Comments on "Sudbury Station" developer proposal

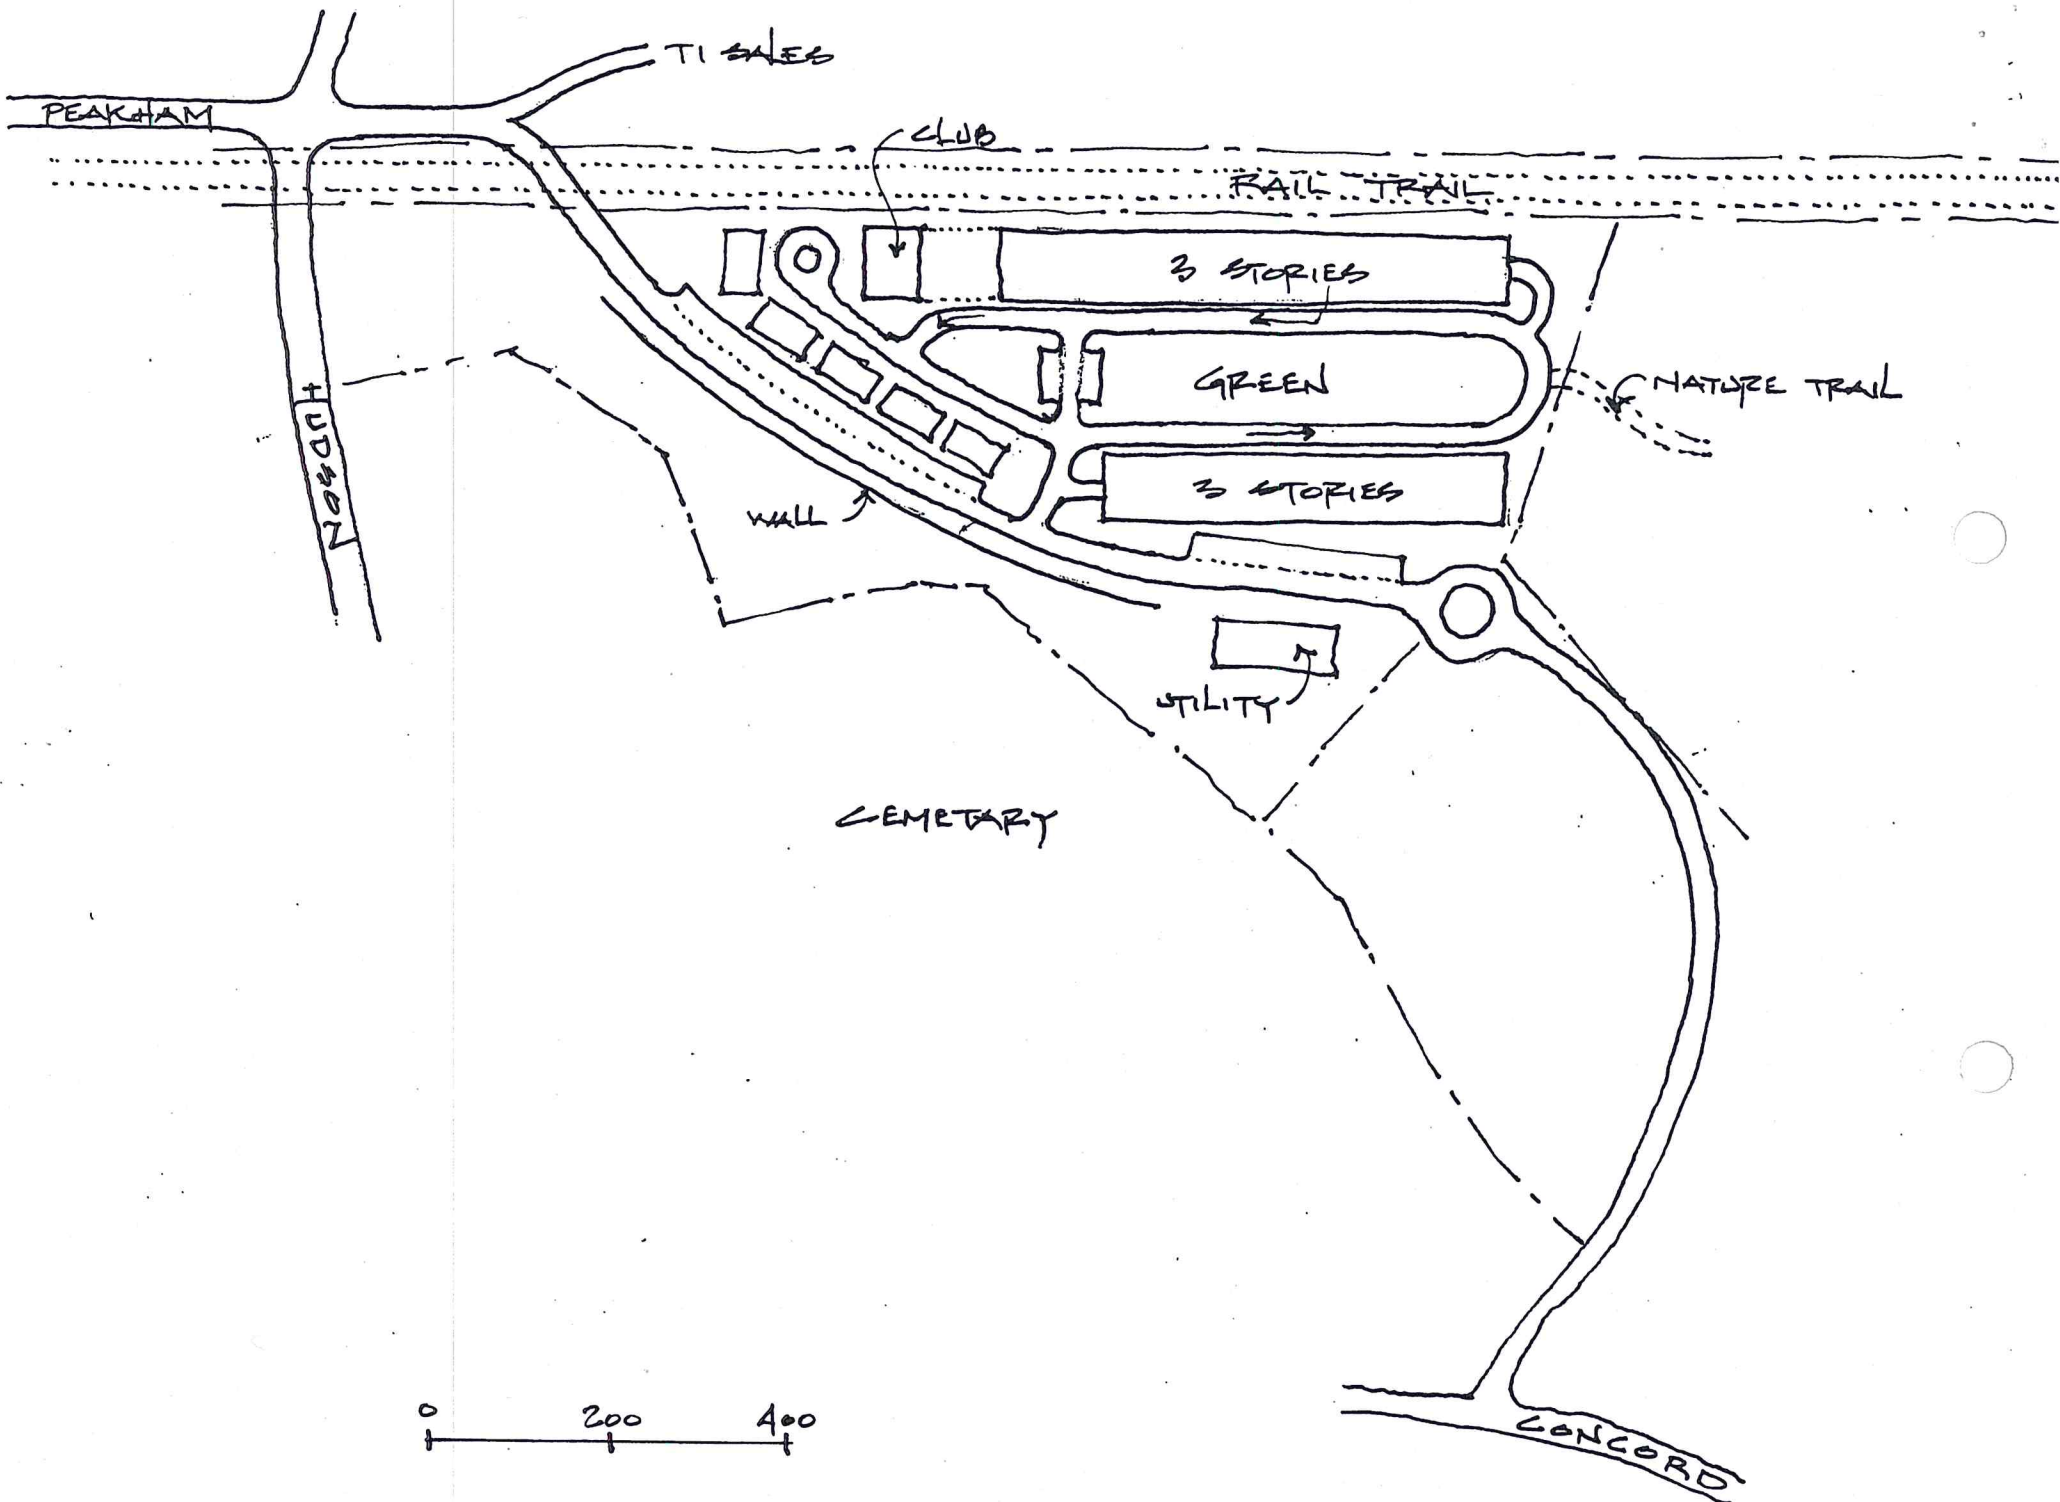
3. **Traffic load and circulation.** We have spent several years in design and construction of the new traffic alignments in the center. 250 units demand a new public roadway to bypass the center. This development should not be fed by one or two private driveways. This should include a public roadway connecting Concord Road with Hudson Road in alignment with Peakham Road, affording traffic relief rather than traffic congestion. See attached sketch.
